**LAND OFF LITTLE GREEN LANE,
CROXLEY GREEN,
HERTFORDSHIRE**

PROPOSED HIGHWAY WORKS

ROAD SAFETY AUDIT REPORT

Document: Stage 1 Road Safety Audit

Appendix A

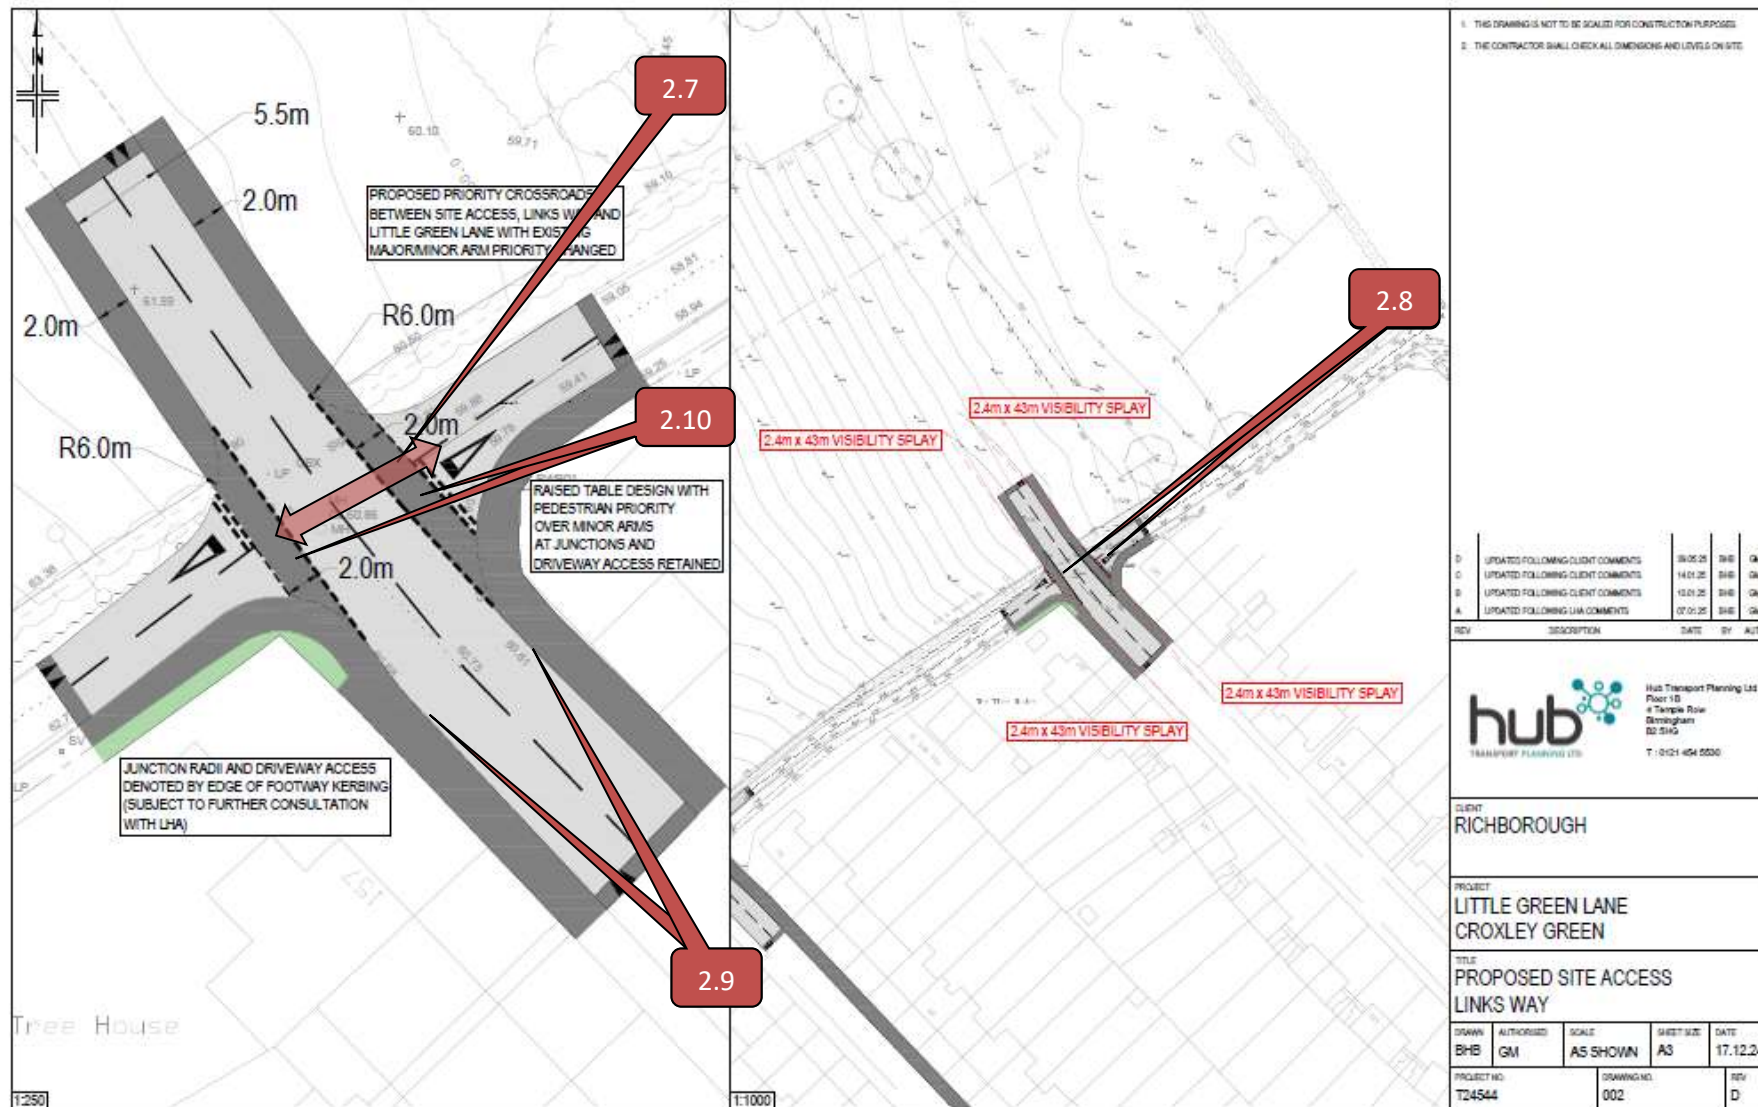
Summary: Potential collisions due to standing water or service covers

No details have been provided in respect of surface water drainage or other services, and it is therefore not possible to ascertain whether there will be any safety implications. The absence of surface water drainage may result in the collection of surface water on the local highway, which could increase the risk of loss of control collisions.

Summary: Potential vehicle collisions due to inadequate road space or visibility

No details have been provided in respect of vehicle swept path assessments and it is therefore not possible to ascertain whether there will be any safety implications. There is concern that that insufficient road space may result in large vehicles overrunning the opposing carriageway when negotiating a turning manoeuvre which may increase the risk of side-swipe collisions with other road users. There is further concern that vehicles may overrun the footway putting pedestrians waiting on the footway to cross the carriageway at greater risk of being struck turning vehicles, particularly at locations where a raised table is proposed where there will be little level difference between the footway and carriageway levels.

Ensure that surface water drainage is provided to mitigate the risk of collection of surface water on the carriageway.

Ensure vehicle swept path assessments are undertaken to ensure large vehicles can negotiate proposed highway layout, if necessary amend the layout.
